DURHAM COUNTY

I-40 and Miami Blvd.

Date: April 4, 2017	County: Durham
Interchange: I-40 and Miami Blvd.	
Location (exit ramp): EB Exit Ramp

I-40/US 421 EB Exit Ramp at NC 66

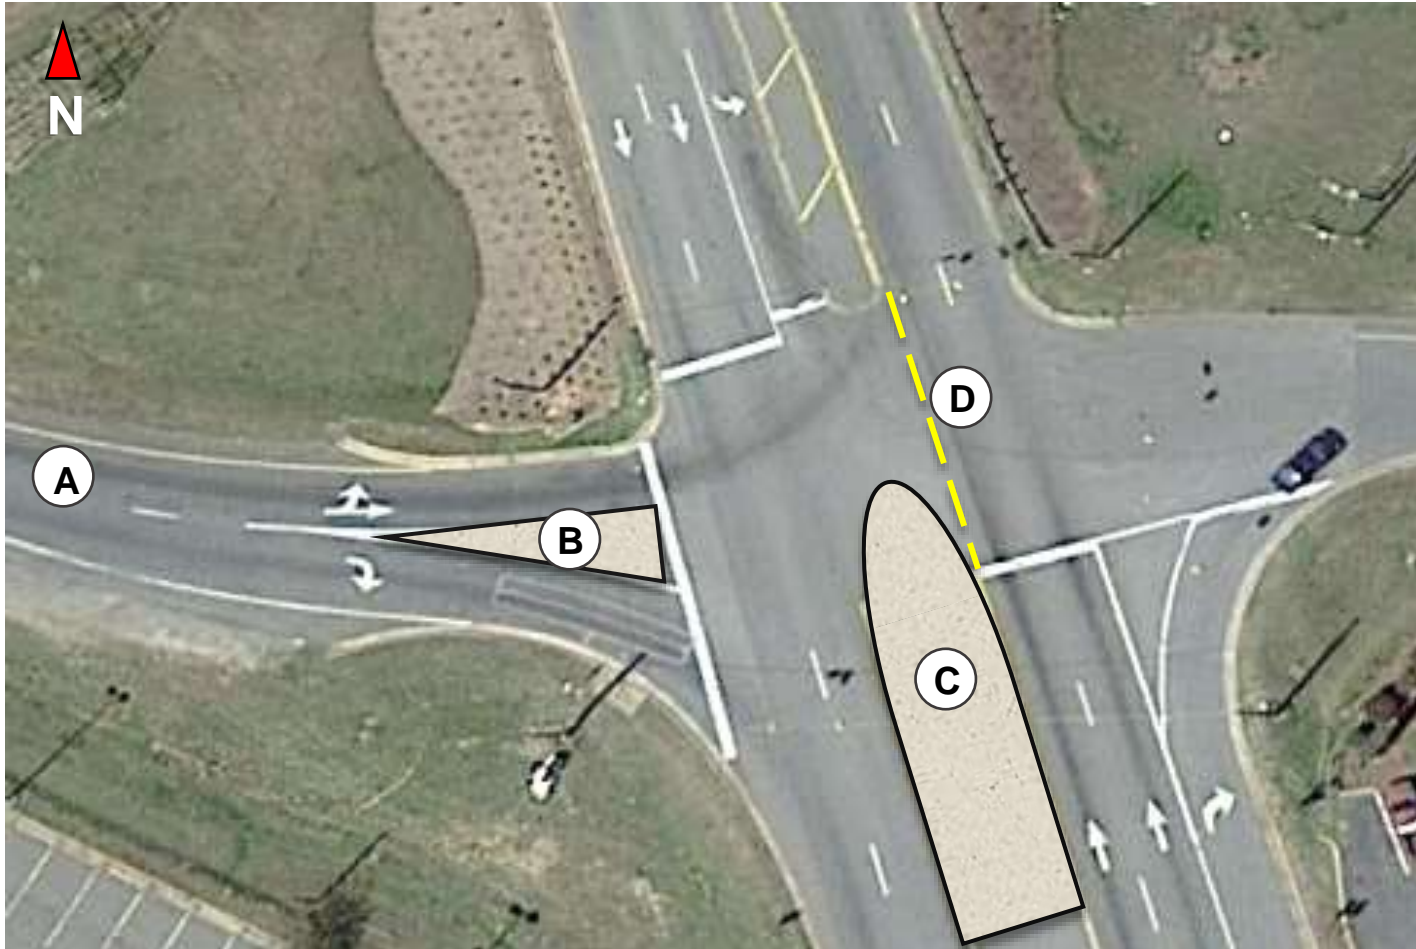
The strongest recommendation at this site would be to incorporate a raised median on NC 66, extending out into the intersection to reduce the possibility of left turns into the exit ramp.

Installing dashed guide lines along the left lane of NC 66 through the intersection may help reduce wrong-way left turn movement.

- A. Add Wrong Way arrows
- B. Add raised splitter island
- C. Add short raised median
- D. Add dashed guide lines

I-40/US 421 WB Exit Ramp at NC 66

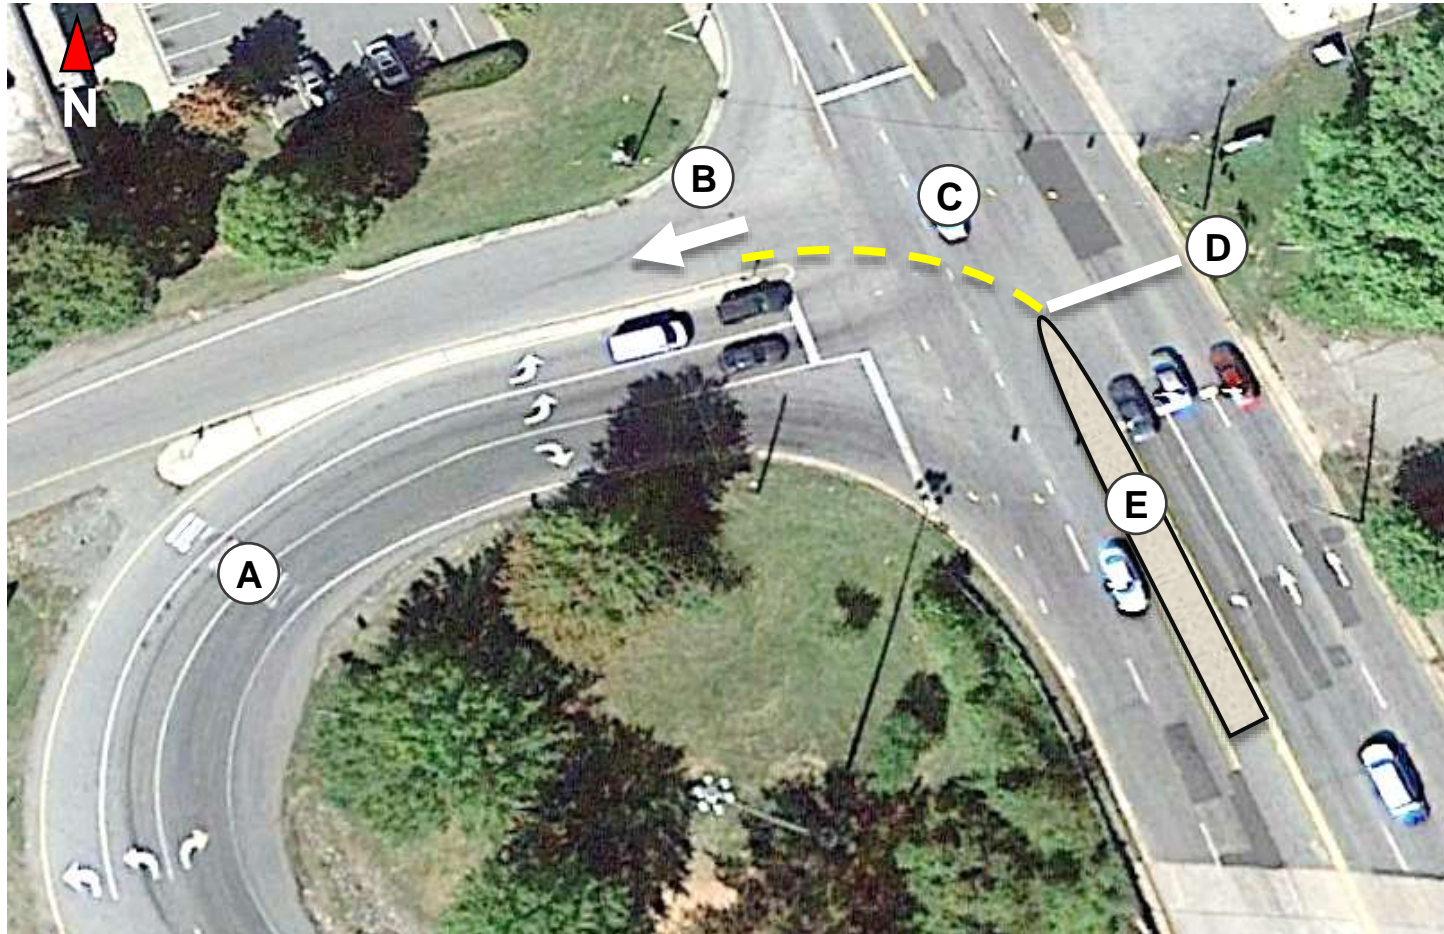
See map for recommendations to move stopping location forward for NB 66 traffic.

- A. Add Wrong Way arrows
- B. Add arrow indicating correct freeway entrance point
- C. Add dotted lane line extension through intersection
- D. Move stop bar forward
- E. Install raised median

US 421 WB Exit Ramp at Lewisville Clemmons Rd.

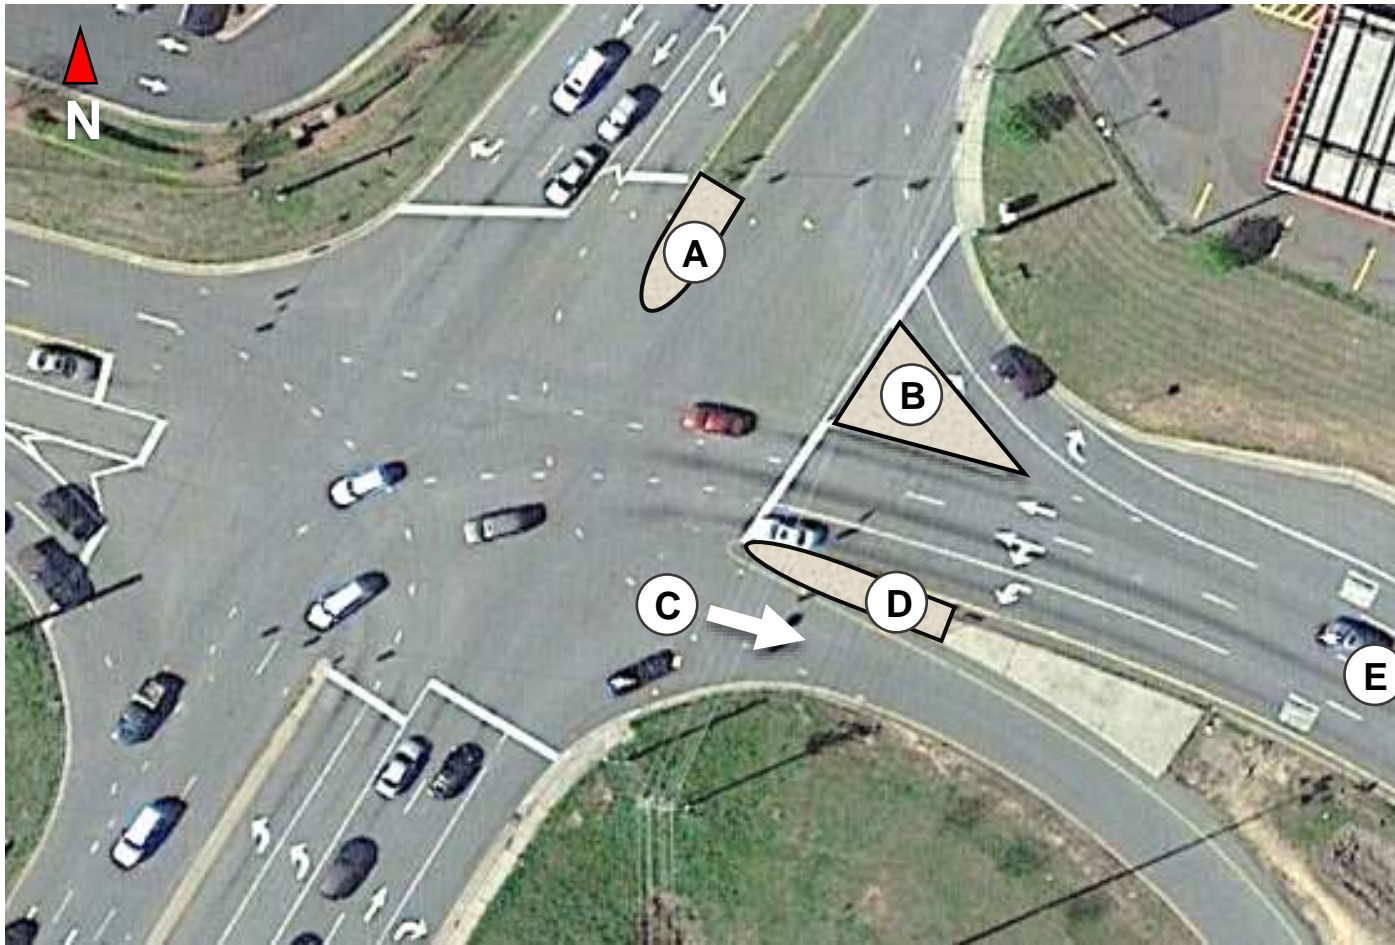
Significant street lighting (4-bulb tall pole) present over entrance ramp area, so additional lighting probably will not help.

- A. Extend median
- B. Convert paint splitter island to raised median
- C. Add arrow indicating correct freeway entrance point
- D. Extend raised median
- E. Add Wrong Way arrows

US 52 SB Exit Ramp at Moore-RJR Rd.

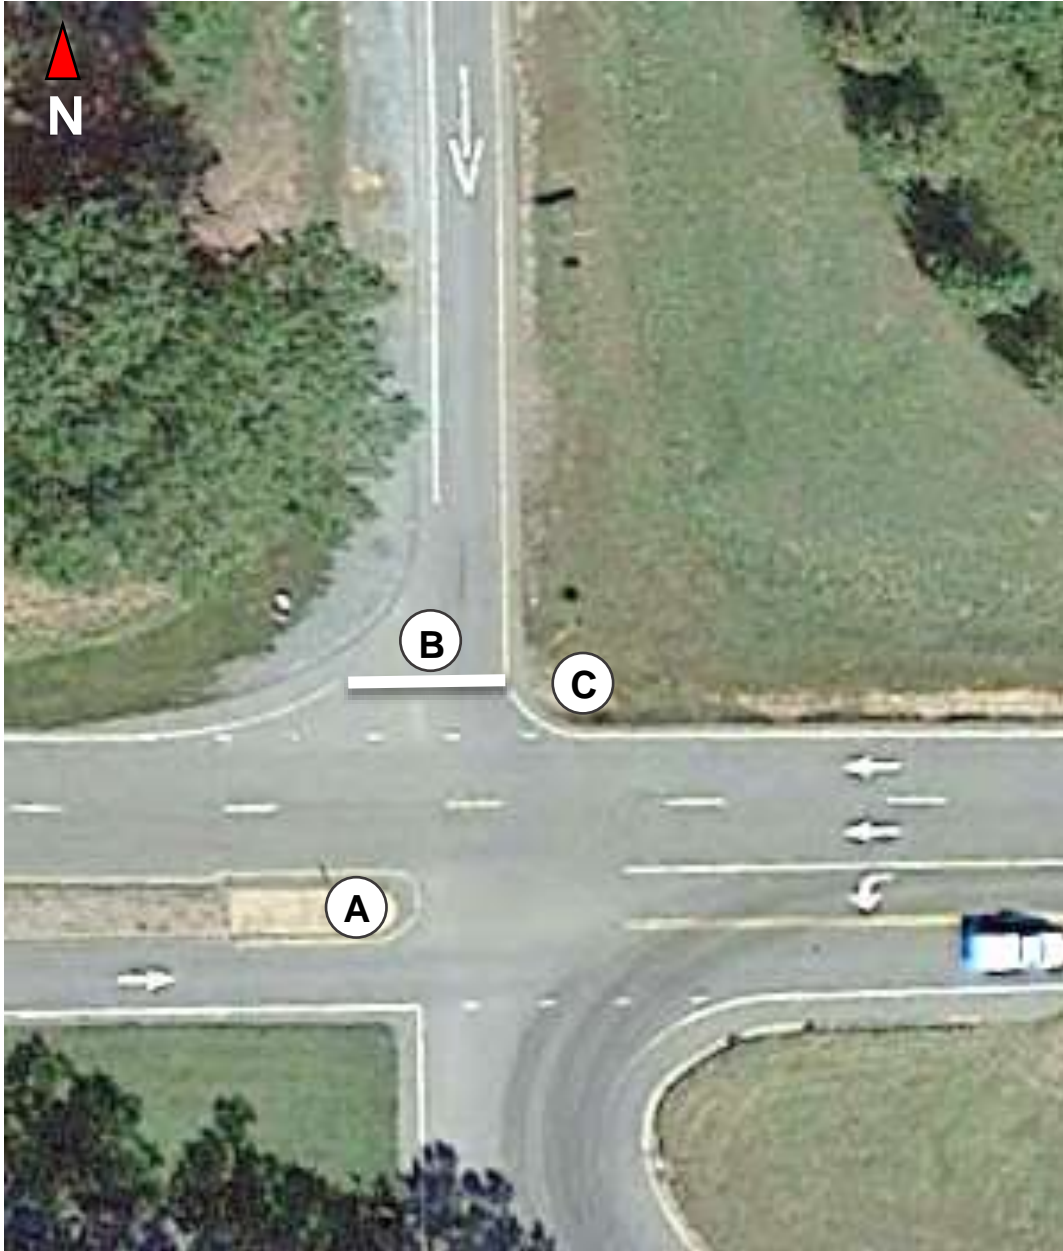
Other Notes: This junction is very well designed to reduce wrong way movements. Crossroad median has good length and placement.

- A. Add No Left Turn sign**
- B. Add stop bar**
- C. Add No Right Turn**

US 52 NB Exit Ramp at Moore-RJR Rd.

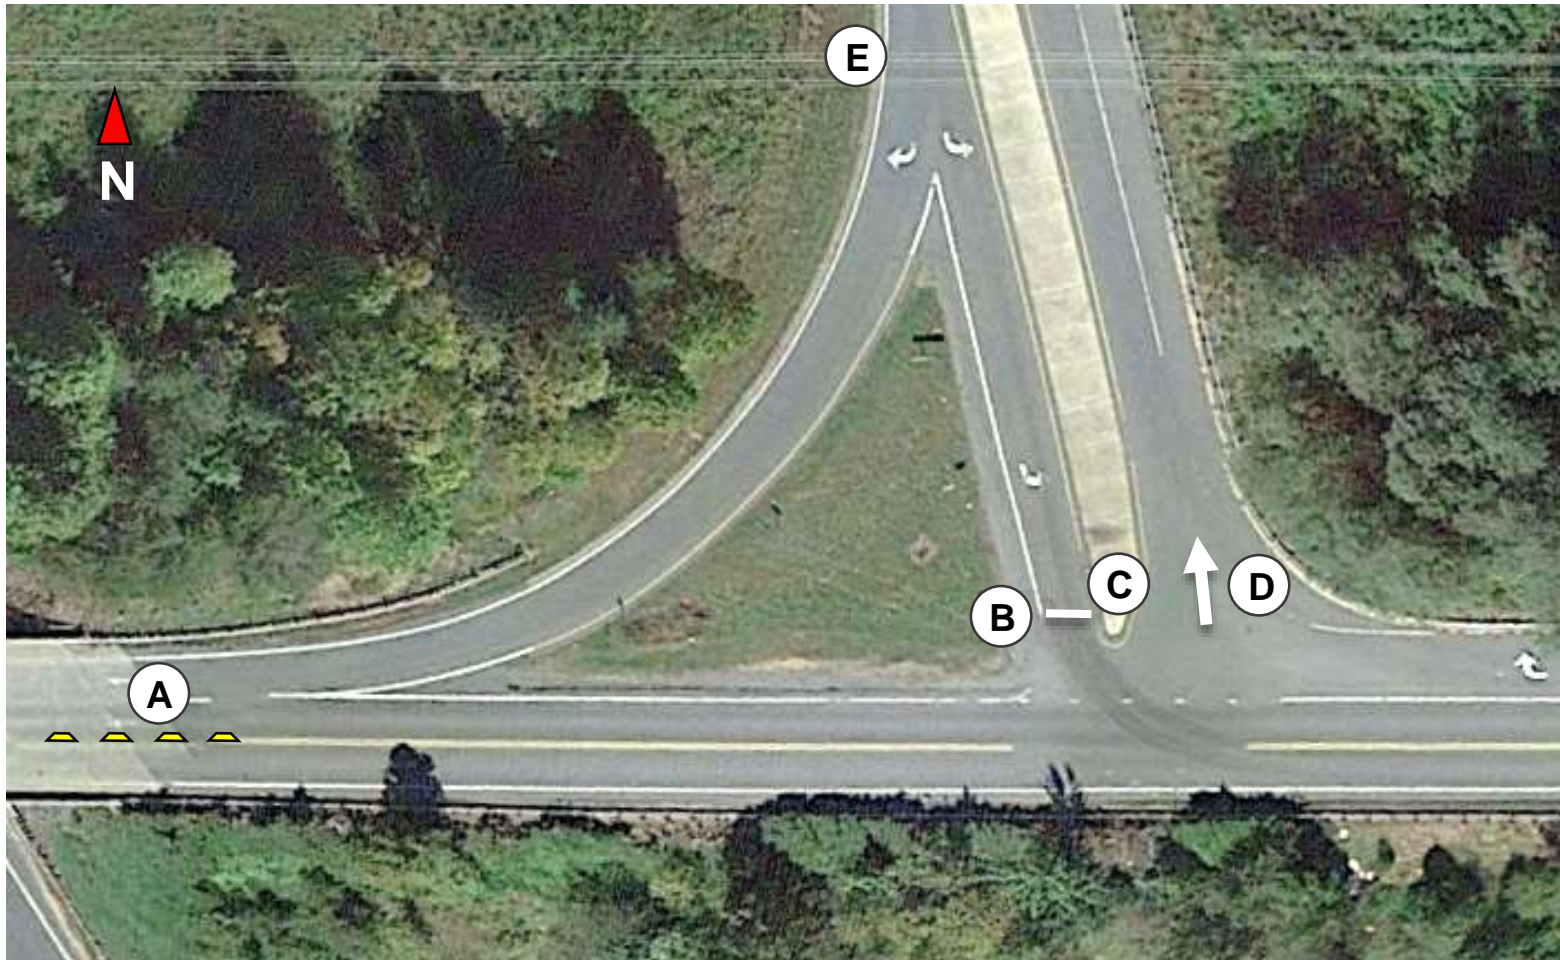
- A. Add flexible median dividers**
- B. Add stop bar**
- C. Add yellow diamond beneath splitter sign and improve visibility of median**
- D. Add arrow indicating correct freeway entrance point**
- E. Add Wrong Way arrows**
